**PROPOSED RESIDENTIAL LED MIXED USE SCHEME.  
UPPER HEYFORD AIRPORT, UPPER HEYFORD, OX25 5TD. (CHERWELL).**

## MEETING NOTES

Project: Upper Heyford

Subject: Environment Agency Meeting

# Areas believed to have suffered from flooding downstream of Heyford Park

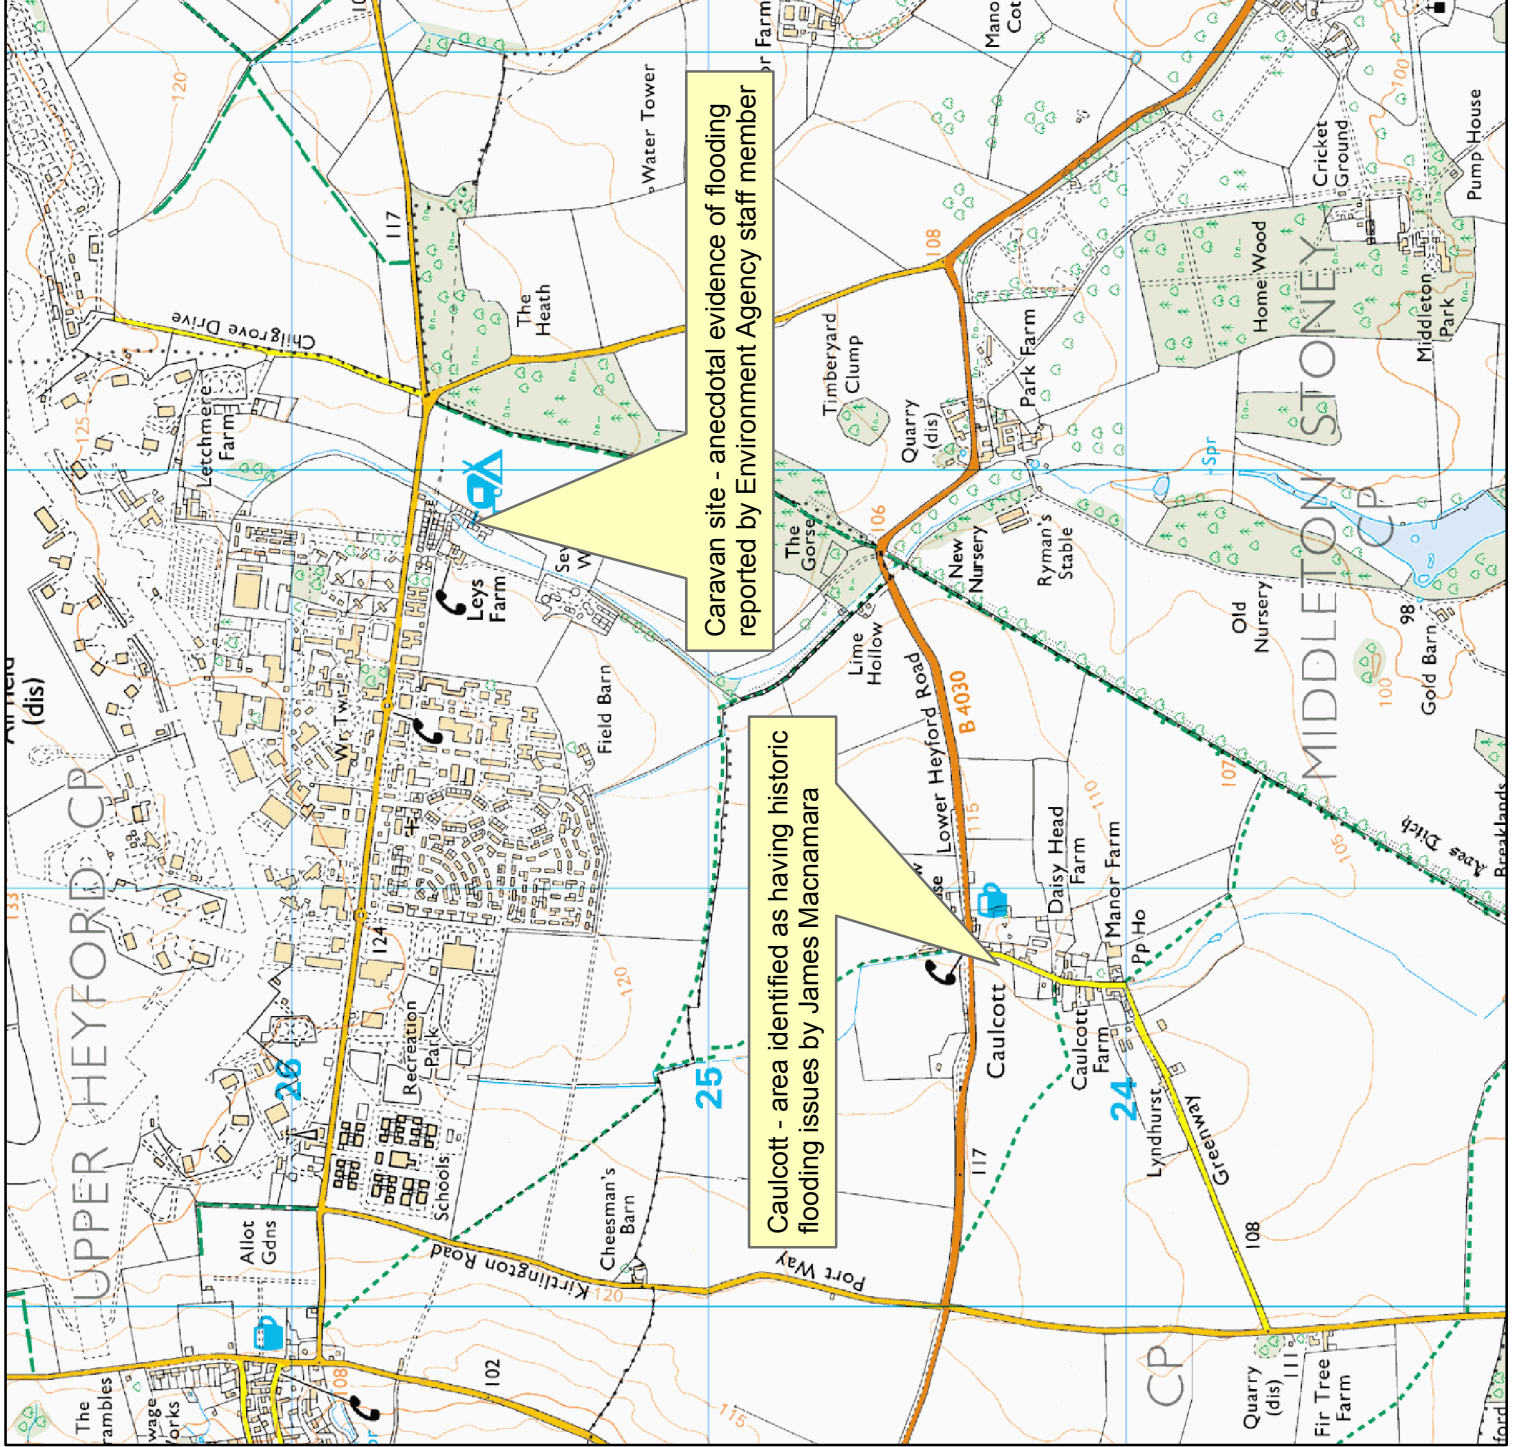
I've attached the letter from James Macnamara, District Councillor of Astons and Heyfords Ward, dated 19th August 2008. I draw your attention to the bottom of the fifth page for his comments on flooding in Caulcott.

I have also attached a plan which identifies Caulcott and the caravan park at which my colleague has suggested there has been historic flooding.

The Heyford Hill site includes large areas of impermeable surfaces and is upstream of both Caulcott and the caravan park, on different tributaries of the Gallos Brook. With the anecdotal historic flooding in mind, I think it is reasonable to expect a reduction in surface water discharge rates from the baseline.

This report of flooding is unsubstantiated. However, to provide a level of betterment it is proposed to limit the rate of discharge over the existing situation within this stretch of watercourse and provide a greater extent of attenuation where appropriate.

The catchment areas draining into this section of watercourse are namely Areas 3 and 4. It is proposed to limit surface water entering this section of watercourse (i.e. from Catchments 3 and 4) by an additional 10% over the existing situation, while accounting for the affects of climate change.

Area 3 (delineated in black) is a constrained central area of the Site which has many functions to perform. It would therefore not be appropriate to provide additional storage in this location. As there is no scope within Area 3 it is proposed to offset the allowable rate of discharge within Area 4. This would require discharge from Area 4 to be

restricted to 82 l/s and necessitate an additional storage volume of approximately 166m<sup>3</sup> (please see attached sketch).
